ADDENDUM NO: 01

BID PACKAGE NO: Kitchen Work Rebid

PROJECT: North and South Decatur Jr. / Sr. High School Additions and Renovations

PROJECT NO: DATE: 02/16/2024 BY: Emery H. M. Hunt

UNDERSLAB
PLAN - UNIT A PLUMBING

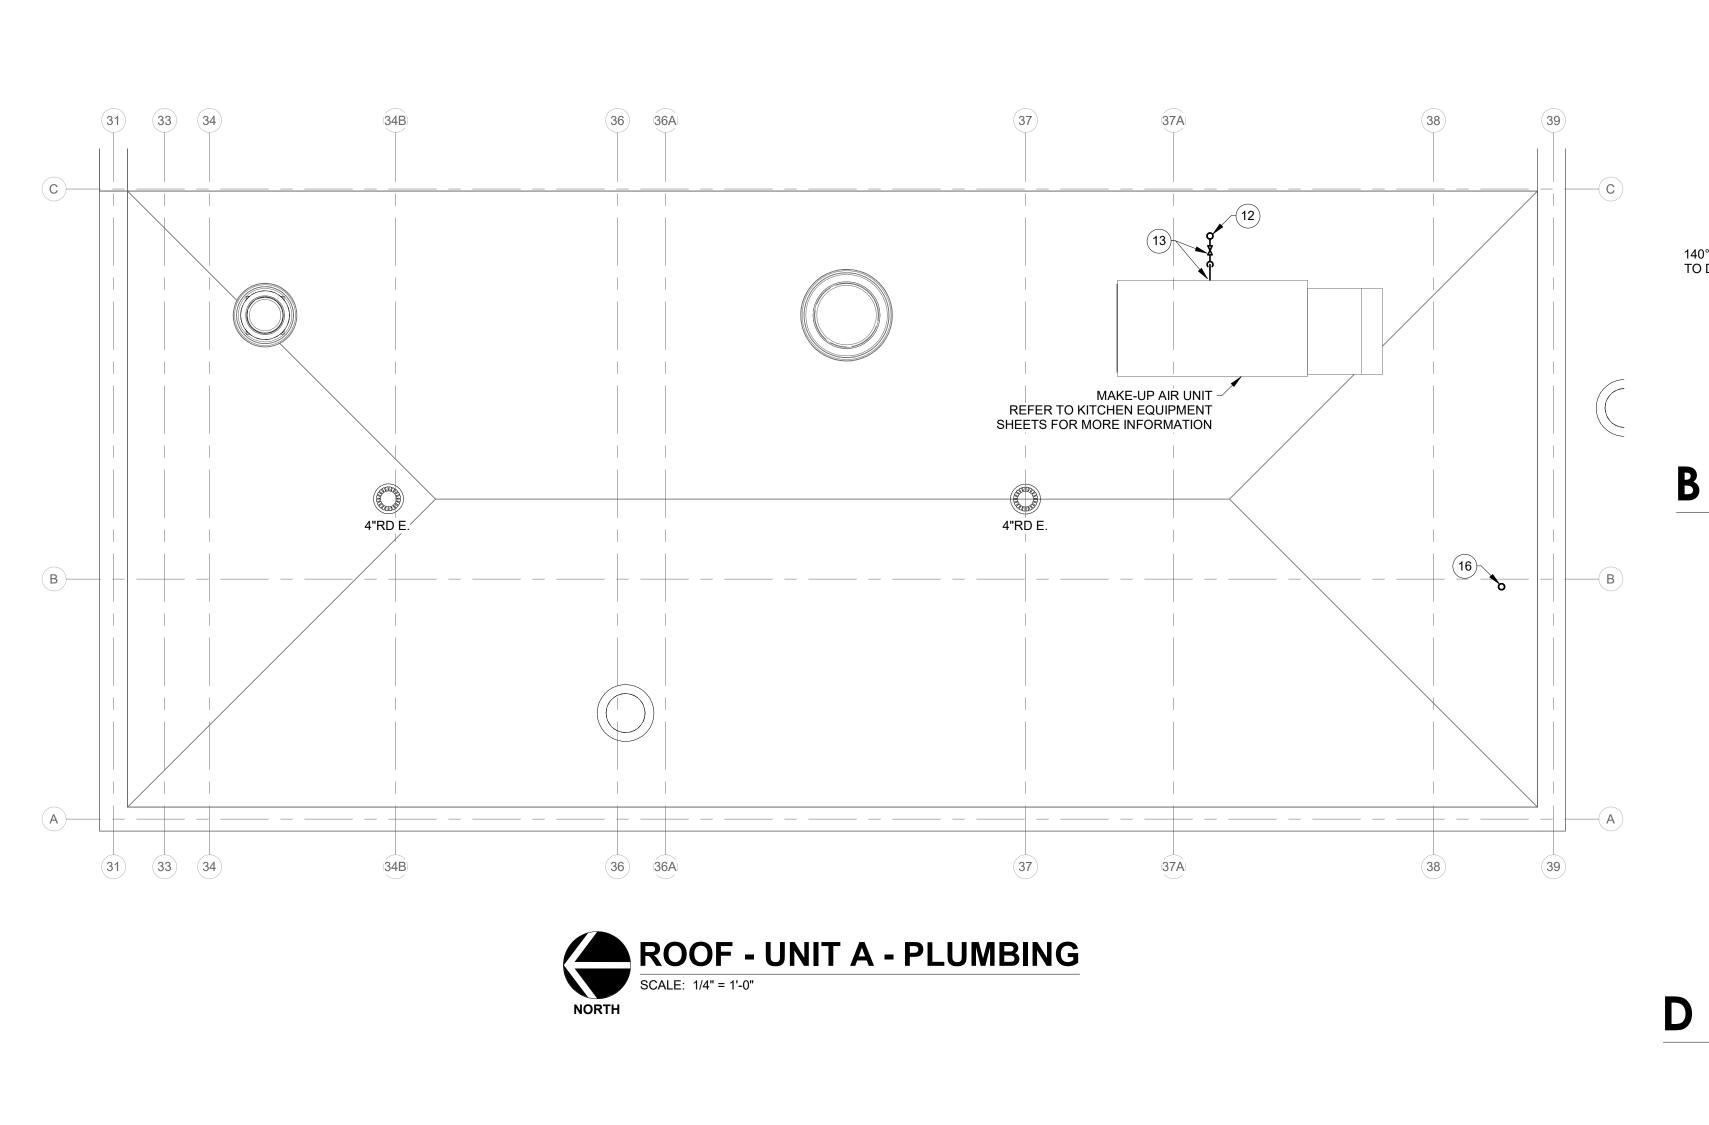
- A. Replace sheet in its entirety.
- B. Floor drain and related piping to remain along column line 36.

FIRST FLOOR - UNIT A - PLUMBING

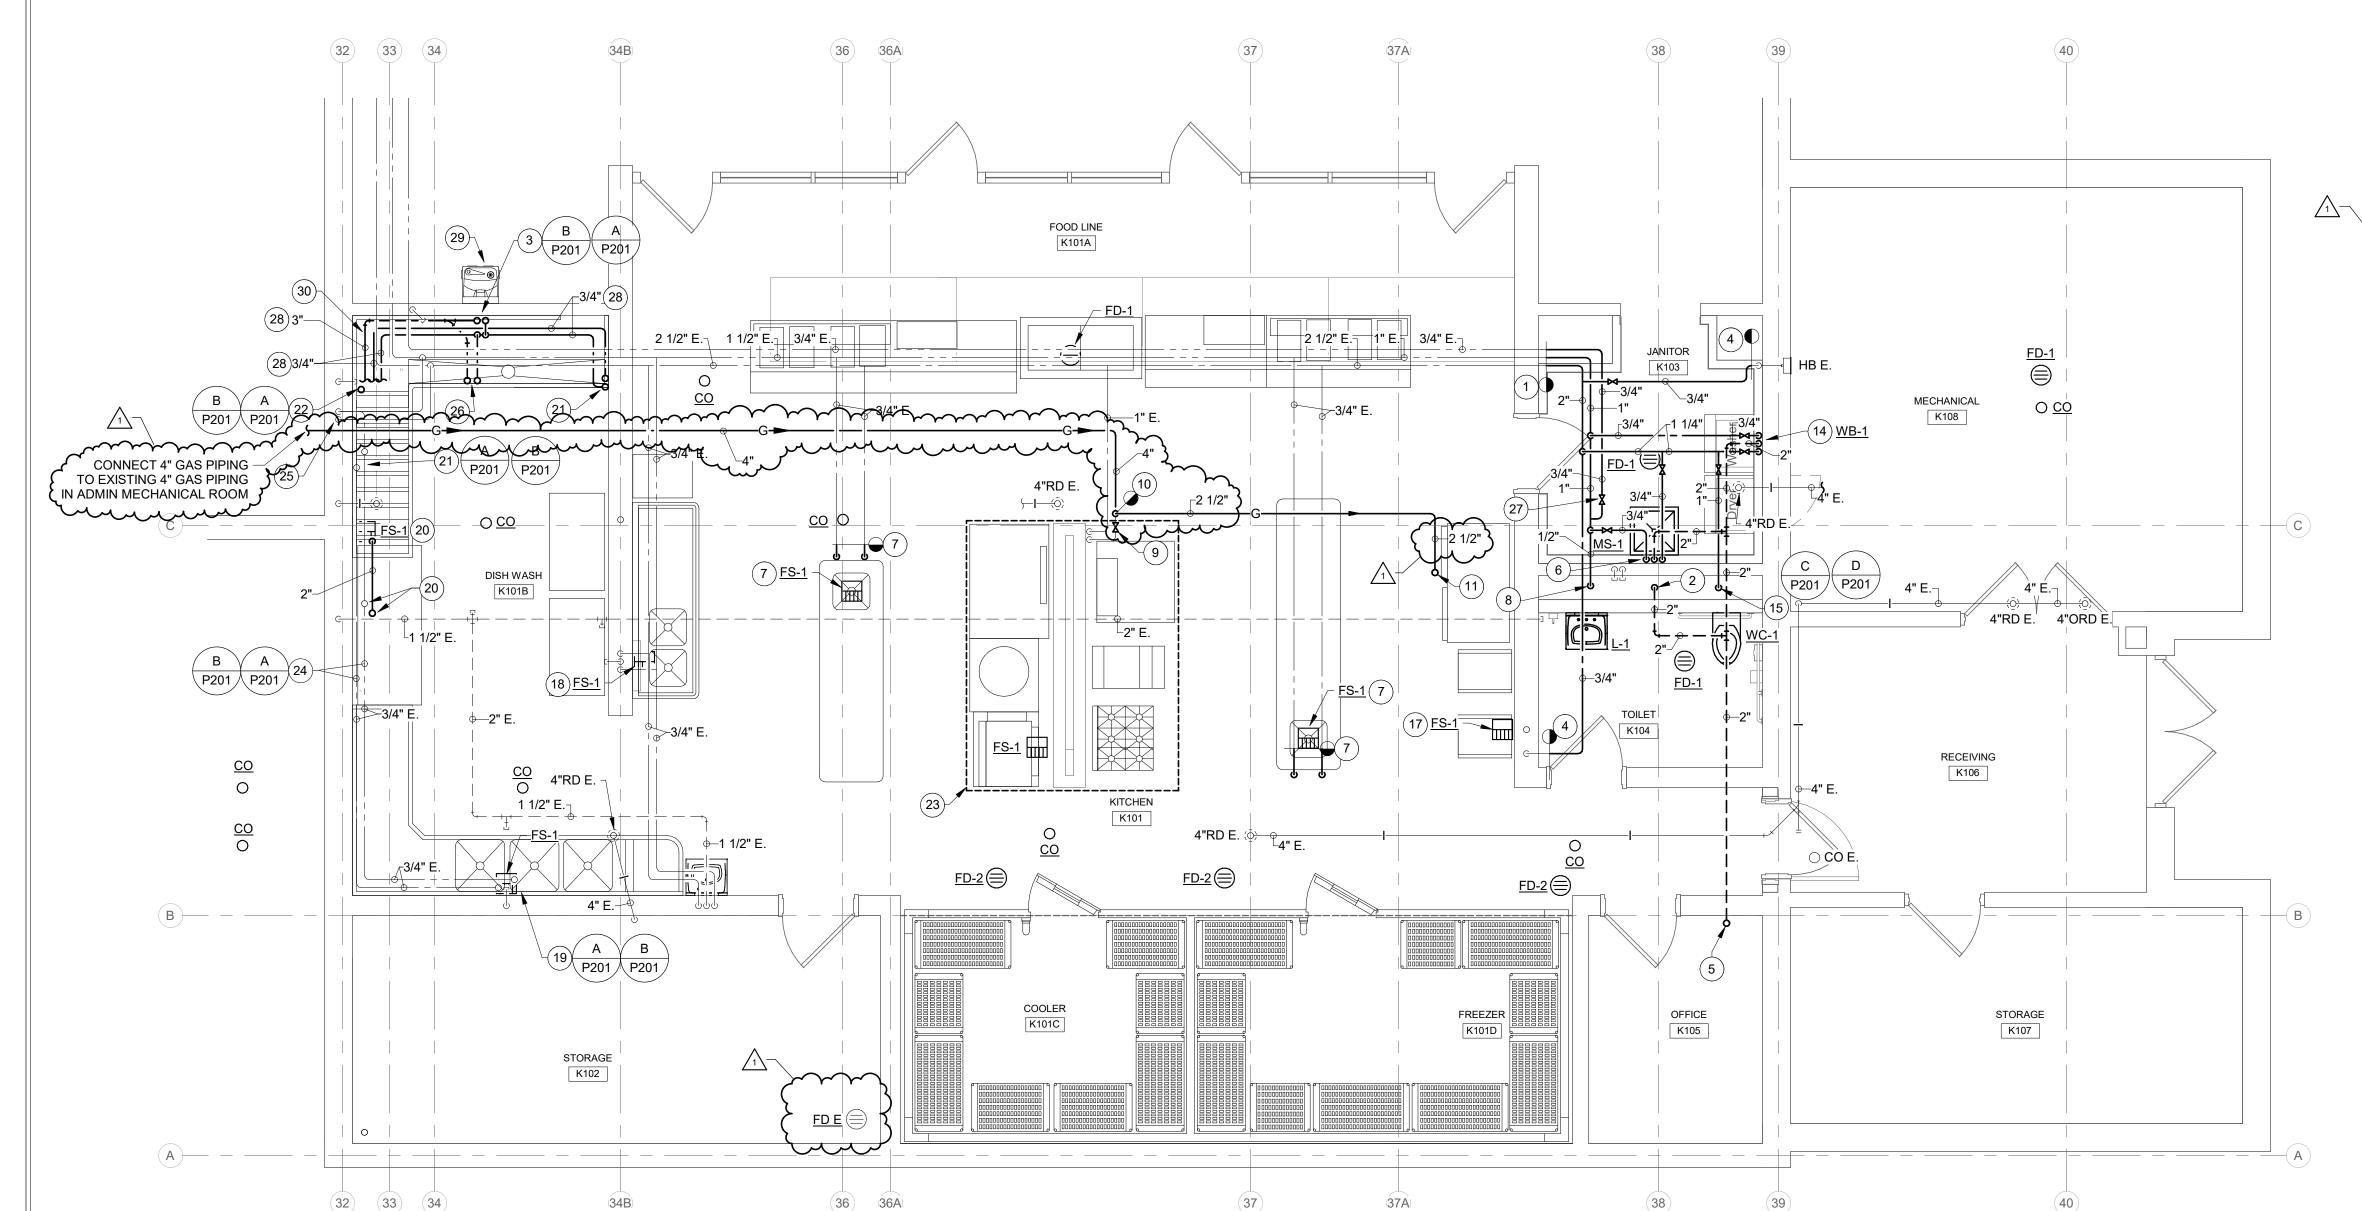
- A. Replace sheet in its entirety.
- B. Extend new 4" gas piping from admin mechanical room to kitchen hood. Reconnect 4" gas piping to existing gas piping serving equipment under the kitchen hood. Tie-in location is approximately 45' to the north on the other side of the Teacher's Lounge. Remove and reinstall ACT ceiling as required to install pipe.
- C. Floor drain in dry storage room to remain.
- D. Change gas pipe size for make-up air unit.
- E. Revise plan note #10, 11, 12, 13, and 29.
- F. Add "GAS SERVICE NARRATIVE" to sheet.

DRAWING TITLE: UNDERSLAB PLAN - UNIT A -PLUMBING **DEMOLITION**

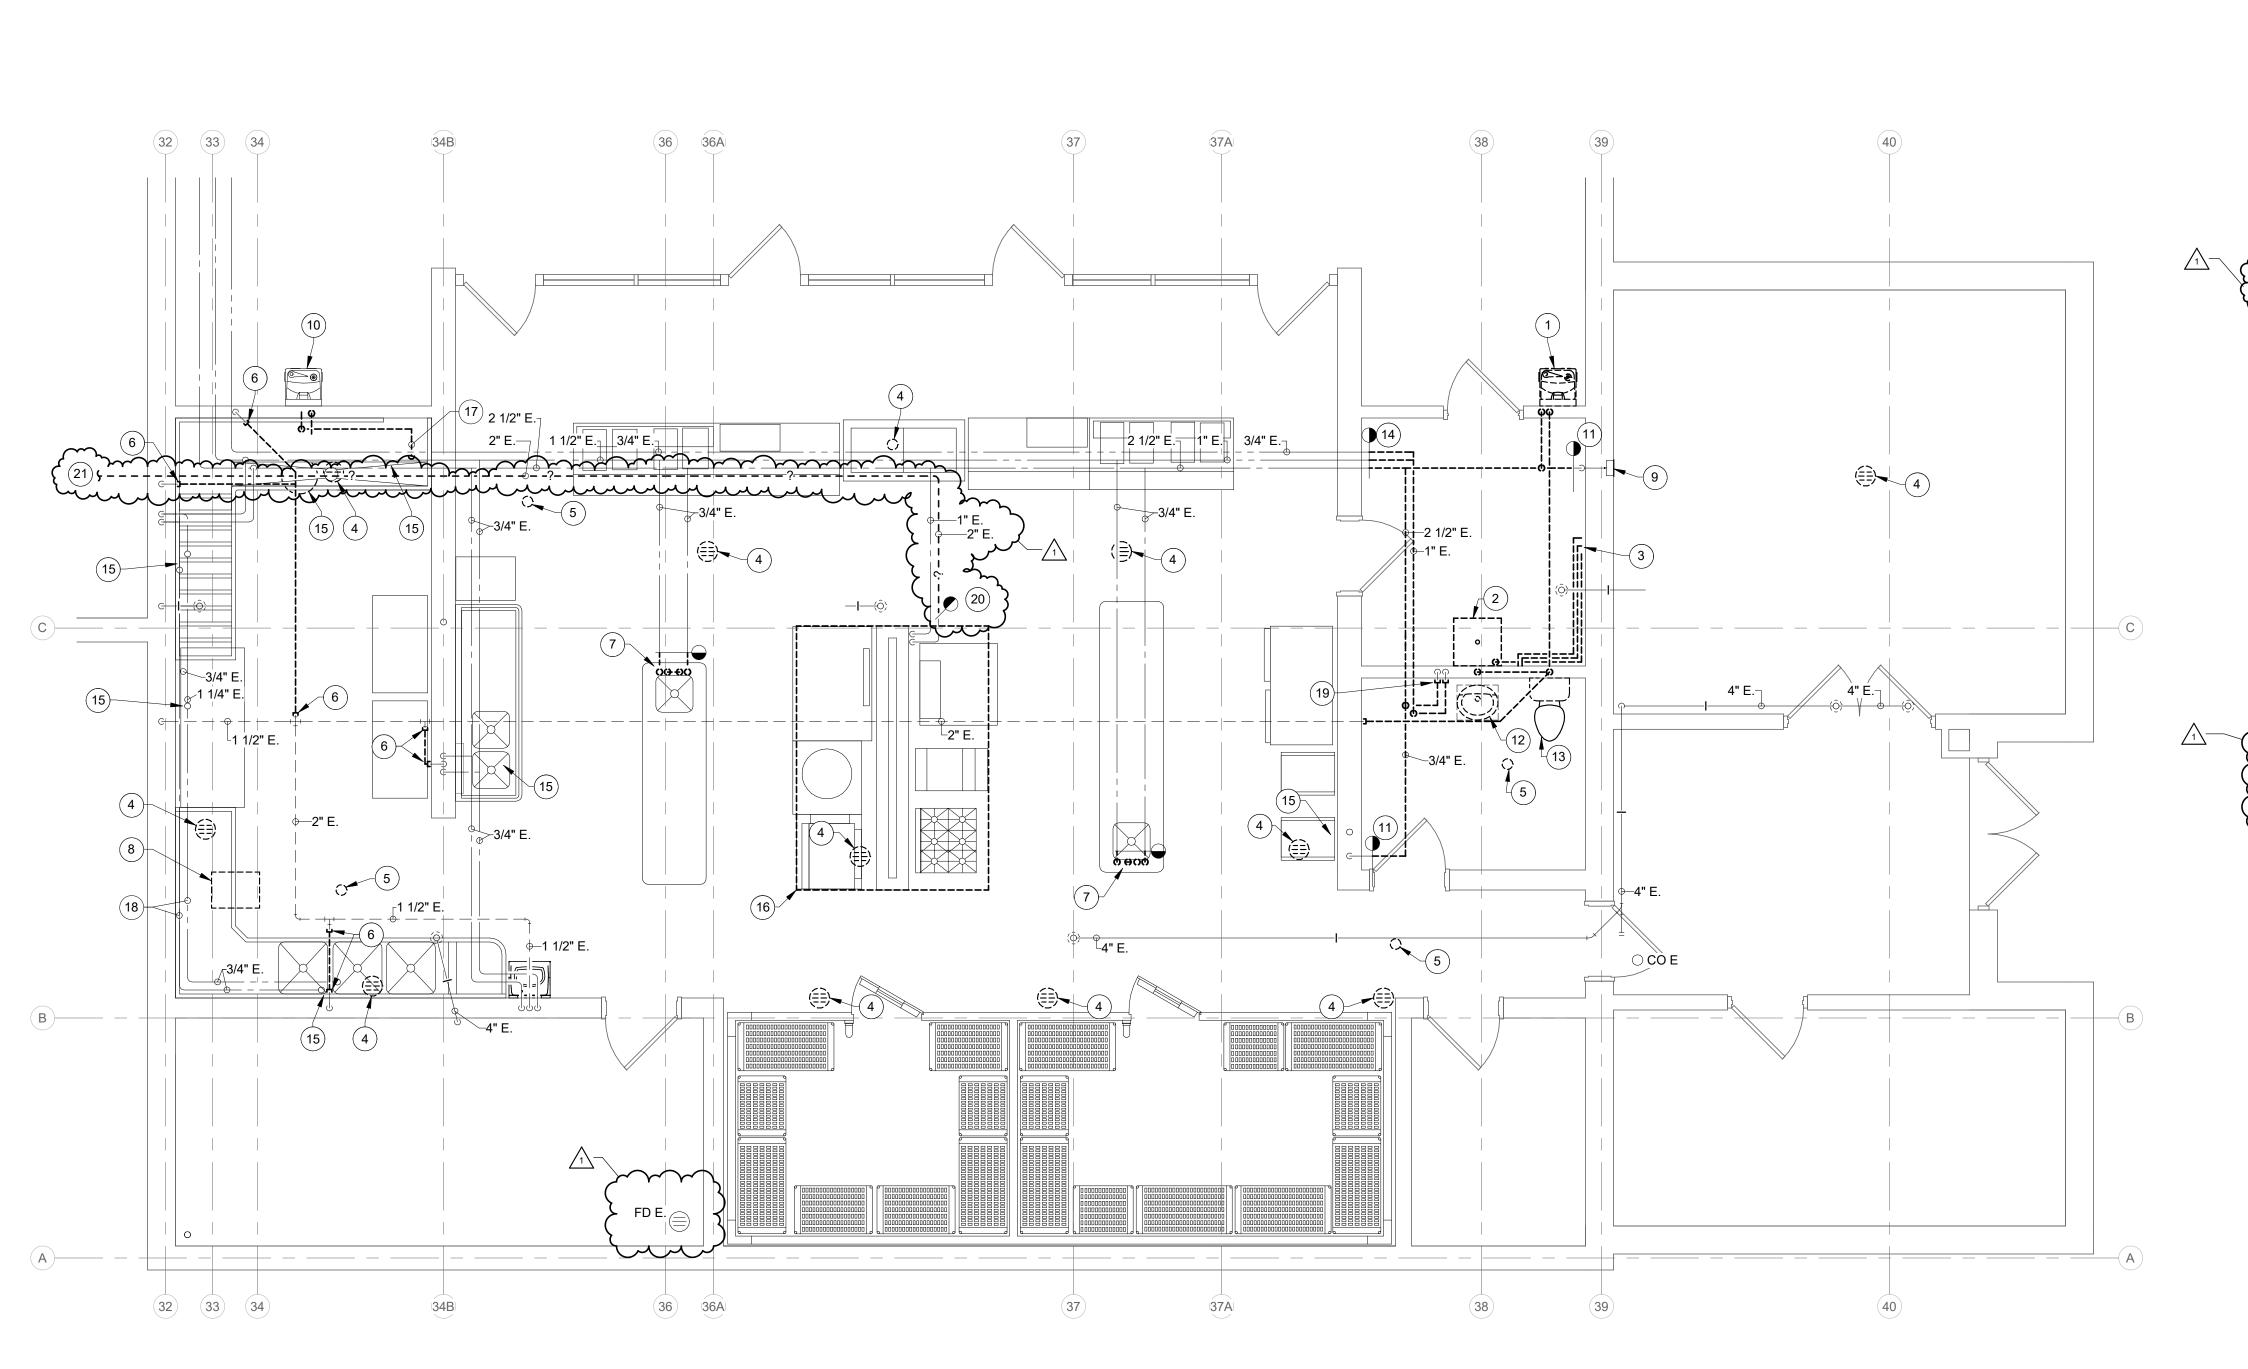
- A. Replace sheet in its entirety.
- B. Floor drain and related piping to remain along column line 36.

FIRST FLOOR
PLAN - UNIT A PLUMBING
DEMOLITION

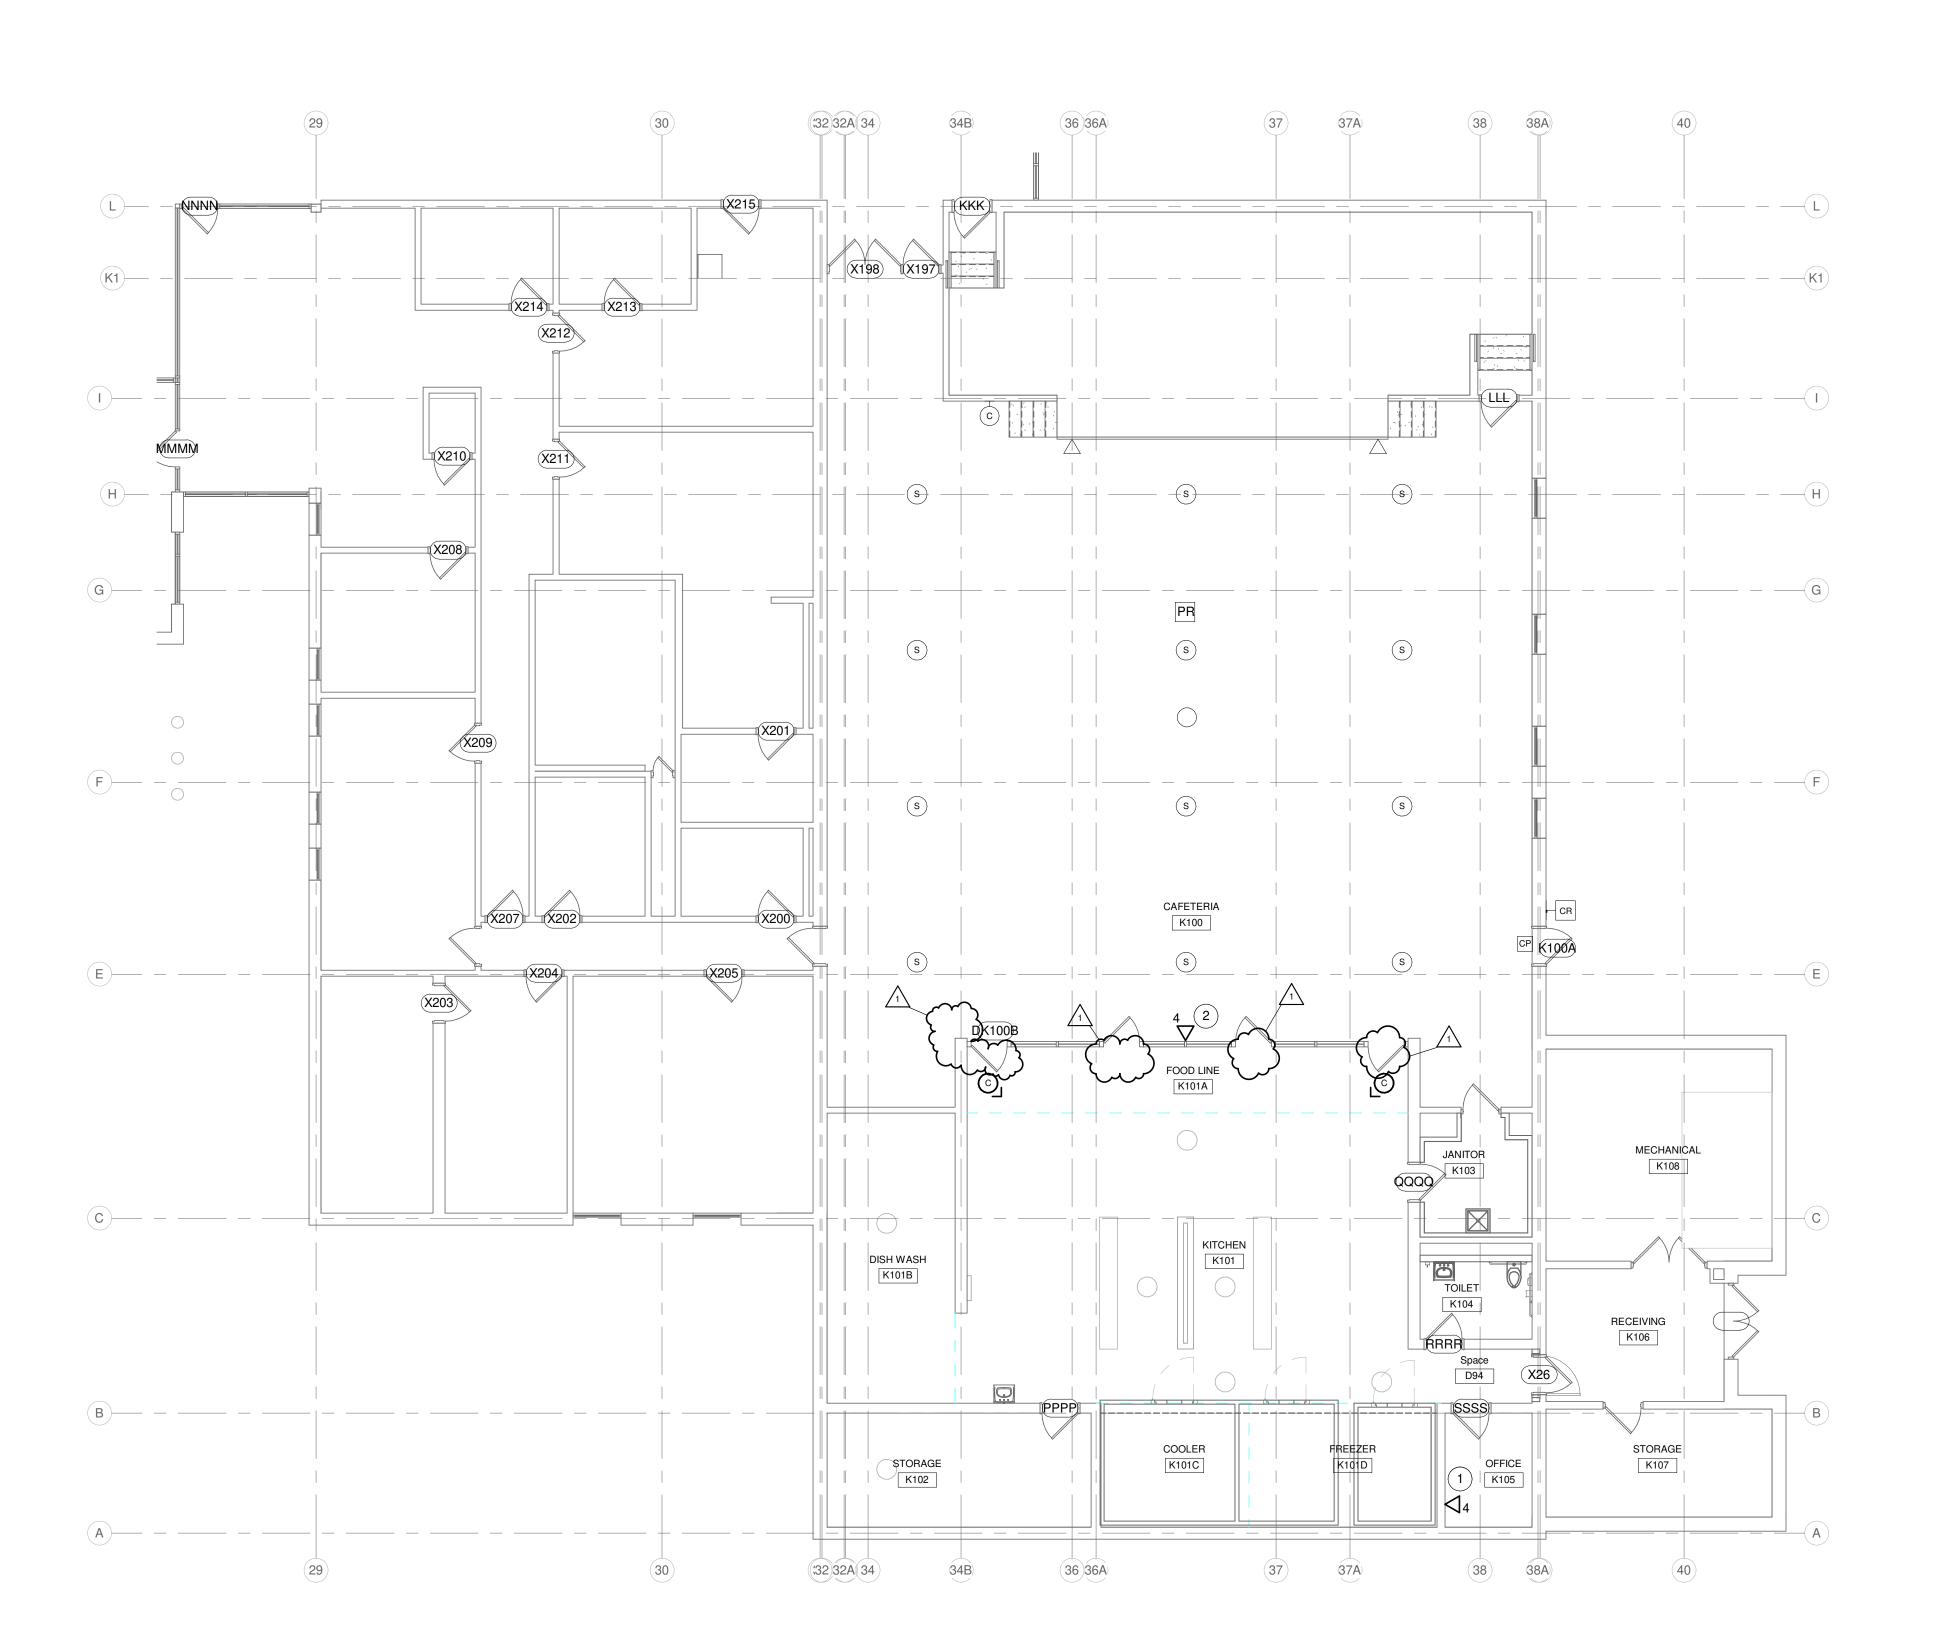
- A. Replace sheet in its entirety.
- B. Remove gas piping from admin mechanical room to kitchen hood.
- C. Floor drain in dry storage room to remain.
- D. Revise plan note #10.
- E. Add plan note #20 AND #21
